Development Review Committee Comments | 8/4/2020
Final Plat Case FP 2020-07
City Point Addition, Blocks 4 thru 10 ("Sector 1")

WRITTEN STATEMENT OF CONDITIONS

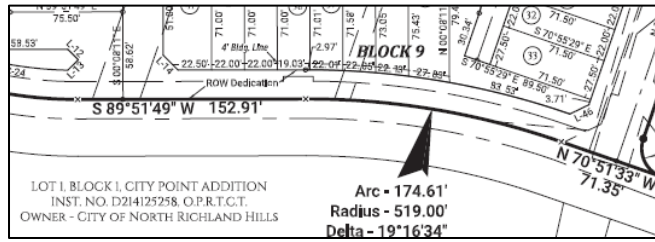
3. Update the owner's certification and dedication statement as shown below. When the property owner is a corporation, the agent signing for corporation should sign their name and include their title. *NRH Subdivision Regulations §110-333 (Additional requirements for plat drawings – dedication certificate)*

NOW, THEREFORE, KNOW ALL MEN BY THESE PRESENTS:

THAT, (Name of Corporation), acting by and through the undersigned, its duly authorized agent, does hereby adopt this plat designating the hereinabove described real property as Lot(s) ____, Block(s) ____, (Addition Name), an addition to the City of North Richland Hills, Tarrant County, Texas, and do/does hereby dedicate to the publics' use the streets, alleys, rights-of-way, and any other public areas shown on this plat.
